Technical Parts Information (TPI) 262 - 018, Coolant Line Bracket (Associated With Engine Flywheel Housing Replacement)

**Coolant Line Bracket
ENG-VE13, EM-USA10****TPI 262-018, Coolant Line Bracket**

W2126009

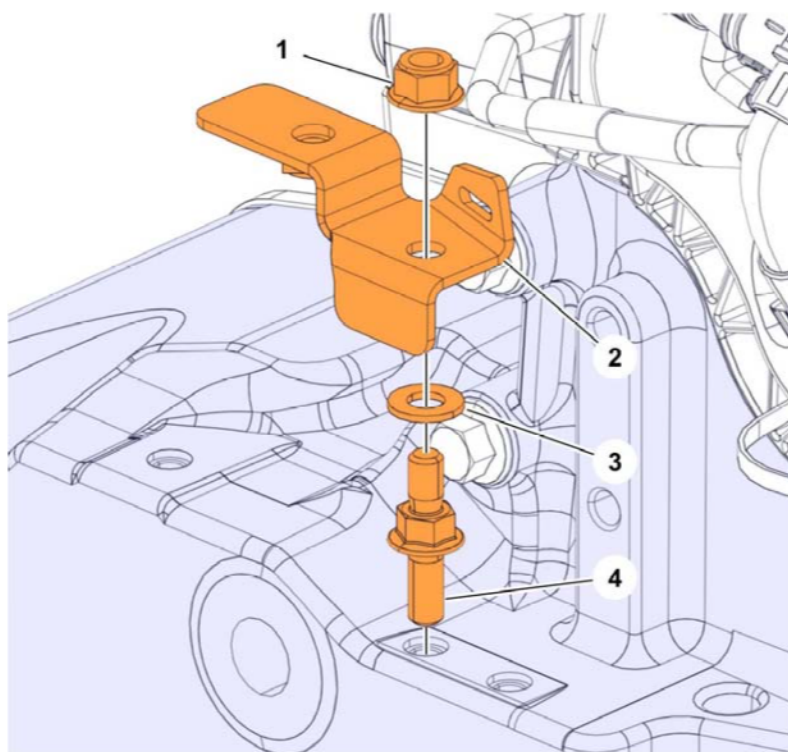
When transferring transmission coolant line bracket (part number 20567404) during flywheel housing replacement, use studed flange screw (part number 20714050), flat washer (part number 3083887) and flange locknut (part number 990950) to mount the bracket to the flywheel housing in the correct angle and clearance.

- Install the flange screw in the flywheel housing and tighten to 24 ± 4 Nm (18 ± 3 ft-lb). Place the flat washer on the flange screw.
- Place the bracket over the flange screw, secure with flange locknut and tighten to 24 ± 4 Nm (18 ± 3 ft-lb).
